NUMBER: 11-001-13

GROUP: Exhaust System

Exhaust Tip Contacting Hitch Causing Buzz, Squeak Or Rattle (BSR)

2013 (WK) Grand Cherokee

Fig. 1 Remove Old Exhaust Tips

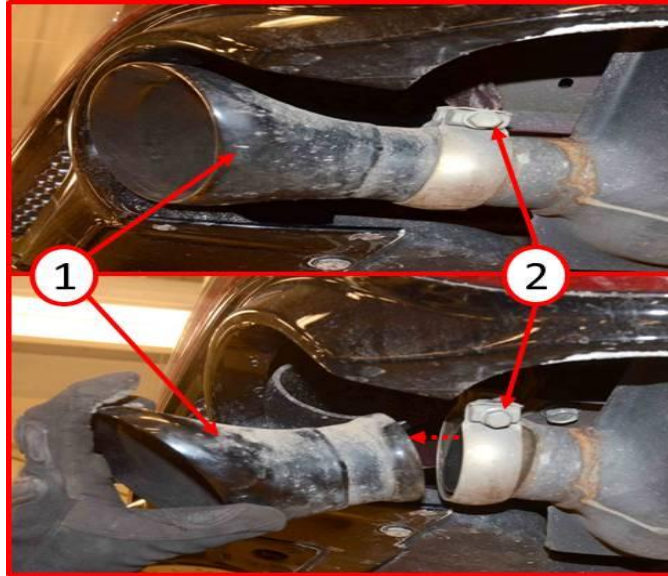
1. Raise the vehicle on a suitable hoist. Refer to the detailed service procedures available in DealerCONNECT> TechCONNECT under: Service Info> 04- Vehicle Quick Reference> Hoisting> Standard Procedure> Hoisting.
2. Remove the right and left side exhaust tips (1) from the vehicle by loosening the bolt (2) on each of the exhaust clamps (Fig. 1).

Fig. 2 Install New Exhaust Tips

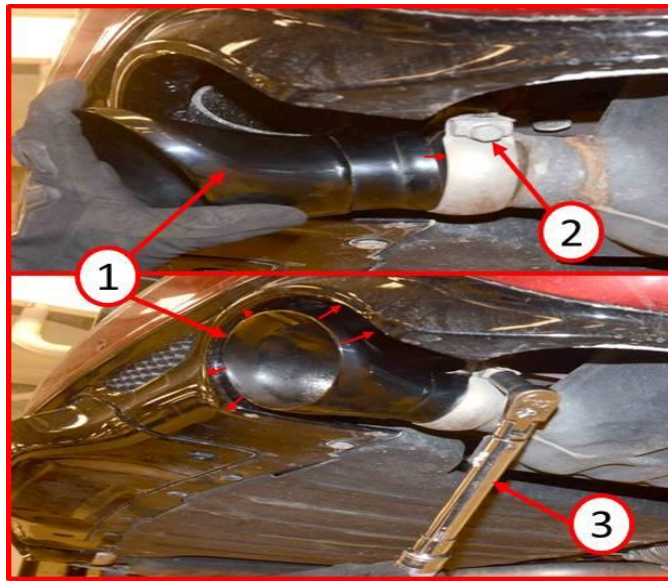
3. Install the new exhaust tip P/N 05181770AB (1) on the left and right side muffler outlets and snug the exhaust clamp bolts (2) so that the exhaust tip can still be adjusted (Fig. 2).
4. Center the exhaust tip (1) in the rear fascia opening and tighten the exhaust clamp bolt (2) using a torque wrench (3) to 22ft/lbs.(30NM)(Fig. 2).
